FIRE SAFETY FOLLOW UP INSPECTION

Factory Name	Taqwa Fabrics Ltd.		Accord ID	9530
Address	Boherachala Gilaberaeed, Kewa, Sreepur			
Initial Inspection Date	26-Apr-2014		Report Received Date	
Date of 1st Follow-up	25-Aug-2015	Date of 2nd Follow-up	21-Mar-2016	
Date of 3rd Follow-up	07-Jun-2016	Date of 4th Follow-up	06-Sep-2016	
Date of 5th Follow-up	27-Nov-2016	Date of 6th Follow-up	08-Feb-2017	
Date of 7th Follow-up	03-May-2017	Date of 8th Follow-up	22-Aug-2017	
Date of 9th Follow-up	03-Dec-2017	Date of 10th Follow-up	18-Apr-2018	
Date of 11th Follow-up	01-Nov-2018	Date of 12th Follow-up	2-Sep-2019	
Date of 13th Follow-up		Date of 14th Follow-up		
Inspected by	A N Faisal Ahmed

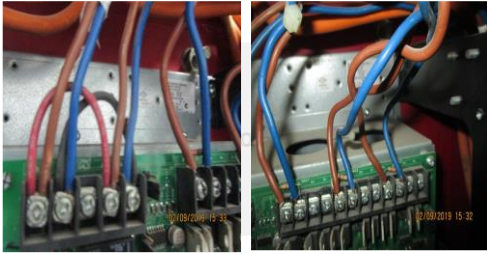
19	New Finding: Handrails are not provided in the exit stair.	Provide handrails on at least one side/both side of exit stair having a minimum height 34 in.	Within 25th September 2015.	On 27-11-16: Corrected. On 08-02-17: Corrected. On 22-08-17: Corrected. On 3/12/17: Corrected. On 18/04/2018: Corrected. On 01/11/2018: Corrected On 02/9/2019: Corrected as per previous follow up.	30-May-2016	Done	Corrected	
20	New Finding: Generator room is not properly separated by fire rated construction with other Occupancies/ Areas	1. Generator room shall be separated from other occupancies by a minimum 2-hr fire rated construction (wall, floor, slab etc.). Seal all penetrations and openings (door, window etc.) should be protected by 1.5-hr fire rated materials to maintain the fire separation if required. All exhaust systems shall discharge to the exterior of the building in a safe location. Or Relocate it to exterior of the building and maintain a minimum 3m (10 ft.) spatial separation distance from the building.	Within 25th September 2015.	On 27-11-16: Corrected. On 08-02-17: Corrected. On 22-08-17: Corrected. On 3/12/17: Corrected. On 18/04/2018: Corrected. On 01/11/2018: Corrected On 02/9/2019: Corrected as per previous follow up.	21-May-2016	Done	Corrected
